Date : 17-19 Nov 2003

Manufacturer: Poly Implants Prostheses, 337 Avenue De Bruxelles, 83507 La Seyne sur Mer, FRANCE

Document Review	Audit observations
Clarification of identity of material components 1 Technical File D.1.2 : "raw material and manufacturing processes for both envelopes is the same" In relation to material equivalency, testing the envelope from the saline filled envelope was used for some testing for the gel filled implant: <u>envelope from saline implant:</u> MED 6400 : xylene dispersion (envelope & patch) MED2 6400: 1,1,1 trichloroethane (tex envelope last layer & patch) <u>envelope from gel implant</u> MED6 6400 : xylene dispersion (envelope, closure & patch) MED 6400: xylene dispersion for 1 st gluing layer How are these equivalent?	MED6 6400 is the 1,1,1 trichloroethane dispersion (TCE) - no longer using 1,1,1 trichloroethane in MED2 6400 as of Feb 2001 → when questioned the Q.C. leader? (Mr. Bosse) answered that the saline + gel envelopes are exactly the same, since TCE not used anymore - advised they need to inform TGA of this change - they said they would send to TGA. - DIFF. b/w MED 6400 - has phenyl groups and MED6 6400 - has vinyl groups instead of phe

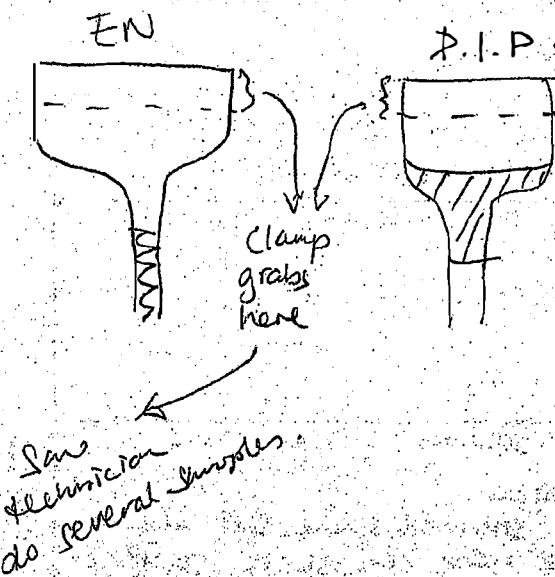
2 The genotoxicity regime you have used does not fully comply to ISO 10993-3. What is the scientific justification for not complying?

ISO 10993-3 "...a series of in vitro tests shall be used. This series shall include at least 3 assays. At least 2 of these should preferably use mammalian cells as a target
